**Addendum No: Four (4)**

**Project: College Oaks Elementary – Hurricane Laura Repairs**

**Architect's Project No: HL-010-01**

**Date: January 21, 2021**

**A3.1**  
SHEET

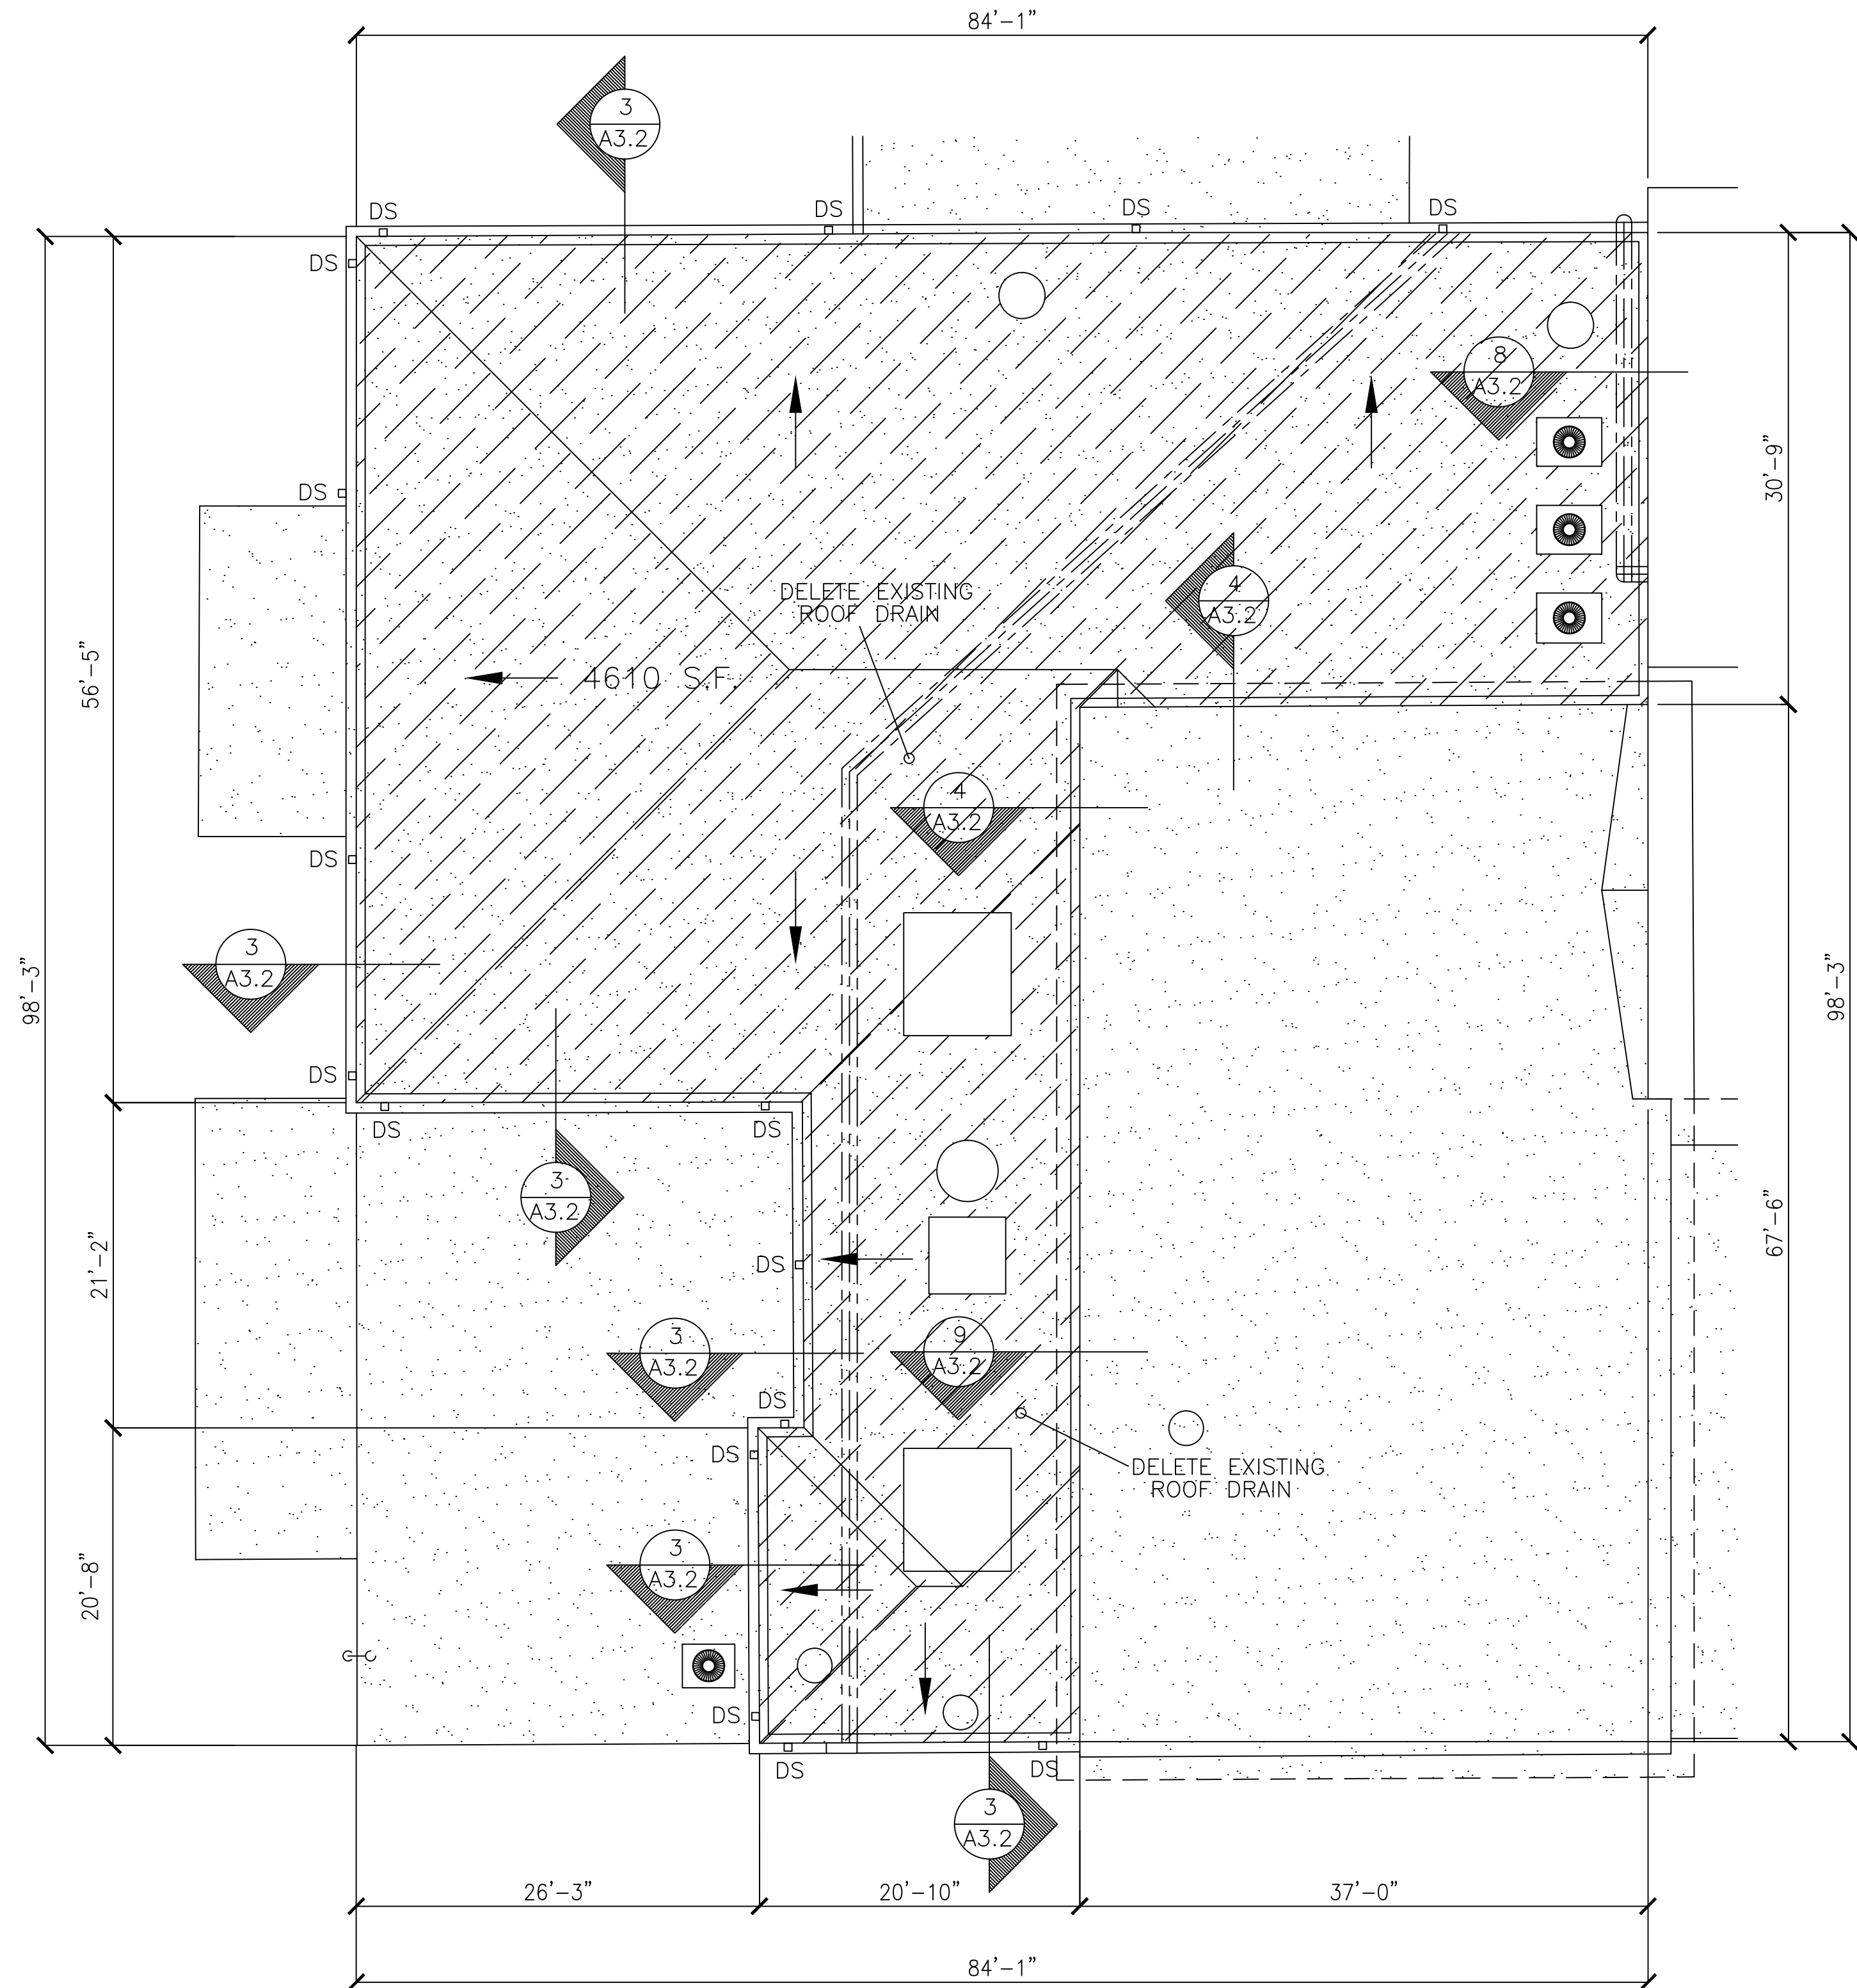
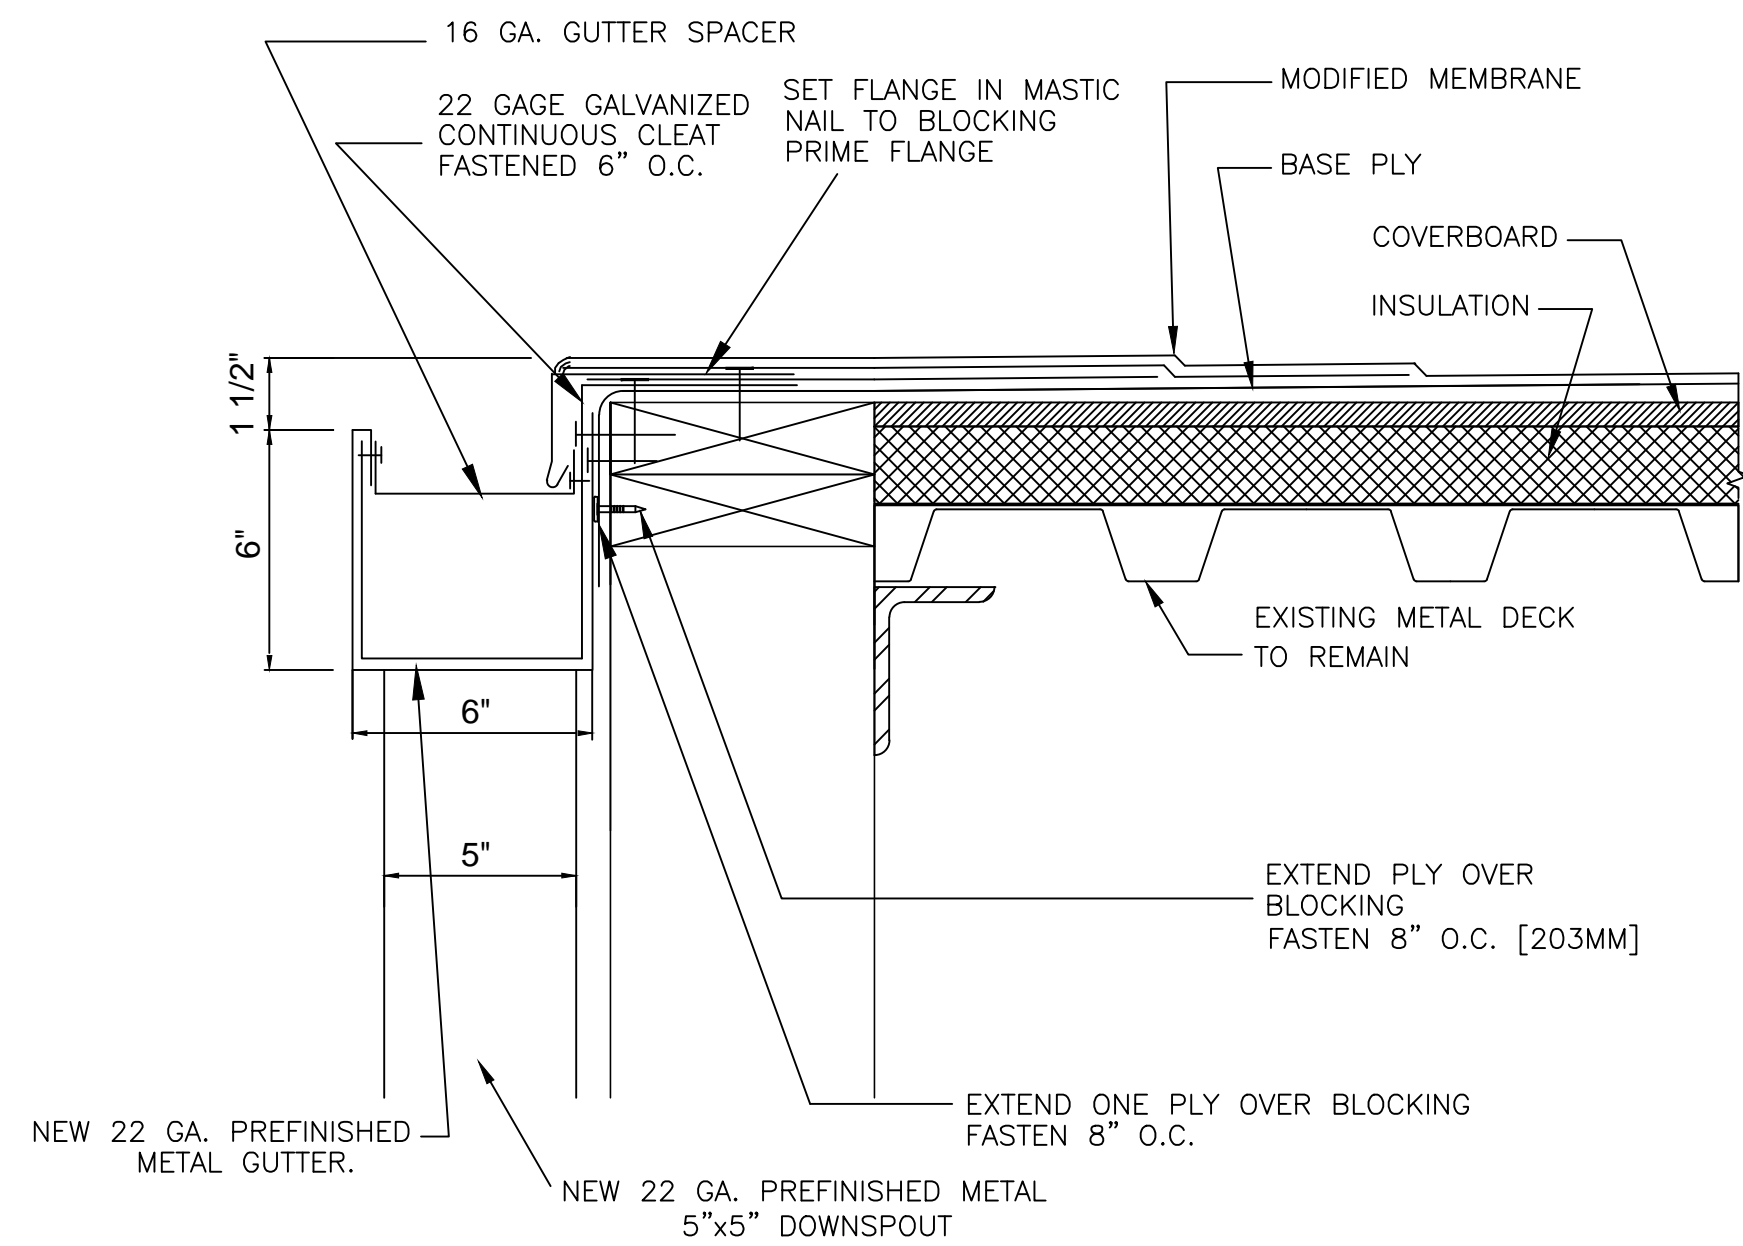
- 7) Sheet A3.1 – Remove existing and replace with revised (See Attached)
- 8) Sheet A3.2 – Remove existing and replace with revised (See Attached)
- 9) Sheets A1.1 & A2.1 – Regarding two (2) temporary buildings to the south of classroom 167 – Contractor shall remove and replace the existing ceiling grid and ceiling tile with new in both (32' x 32') buildings. New ceiling tile shall be Armstrong 1728A 2x2 or approved equal. Contractor shall remove (3' x 3') broken glass window and replace with new. Seal to existing window frame.
- 10) Sheet MP1.1 – Remove and replace with revised (See Attached)

- REMOVE EXISTING GRAVEL, ROOF INSULATION, METAL PAN AND RELATED SHEET METAL ITEMS DOWN TO THE EXISTING SUBSTRATE.
- AT ALL METAL DECK AREAS, RESECURE DECKING AT ZONES 2 AND 3 PRIOR TO INSTALLING SPECIFIED INSULATION.

- AT AREA BETWEEN METAL DECK AND WOOD DECK AREAS, INSTALL NEW HIGH PROFILE EXPANSION JOINT.
- AT GYPSUM DECK AREA, LOOSE LAY VENTED BASE SHEET ACROSS THE ROOF AREA.

- AT ALL DECK TYPES, MECHANICALLY ATTACH SPECIFIED POLYISOCYANURATE, TAPERED POLYISOCYANURATE AND GYPSUM BOARD TO THE SUBSTRATE AS SPECIFIED.
- HEAT FUSE ONE PLY OF SBS MODIFIED BASE SHEET OVER THE INSULATION.

- FABRICATE AND INSTALL ALL MISCELLANEOUS SHEET METAL ITEMS. STRIP IN WITH SBS MODIFIED BASE SHEET.
- FLASH ALL WALL FLASHING AND CURB TYPE PENETRATIONS WITH ONE PLY OF THE SPECIFIED SBS MODIFIED BASE SHEET.

- COORDINATE ALL ROOF TOP MECHANICAL EQUIPMENT REMOVAL AND REPLACEMENT WITH MECHANICAL SHEET MP1.1
- REMOVE AND CLOSE OFF EXISTING ROOF DRAINS AT EXISTING LOCATIONS (3 TOTAL).

- INSTALL ONE PLY OF A HIGH-PERFORMANCE MINERAL SURFACED MODIFIED CAP SHEET ACROSS THE FIELD OF THE ROOF AND UP 2" ABOVE CANT STRIP.
- IMMEDIATELY BROADCAST GRANULES INTO BLEED OUT.

- INSTALL ONE PLY OF A HIGH-PERFORMANCE MINERAL SURFACED MODIFIED CAP SHEET AT ALL WALL FLASHING AND CURB TYPE PENETRATIONS.
- INSPECT ROOF AREA WITH OWNER AND OWNER'S REP PRIOR TO SURFACING.

- AFTER 30 DAYS, APPLY TWO APPLICATIONS OF THE SPECIFIED PROTECTIVE COATING.
- ISSUE A 30 YEAR NO DOLLAR LIMIT (NDL) WARRANTY TO INCLUDE ALL METAL EDGE CONDITIONS AND PENETRATIONS.
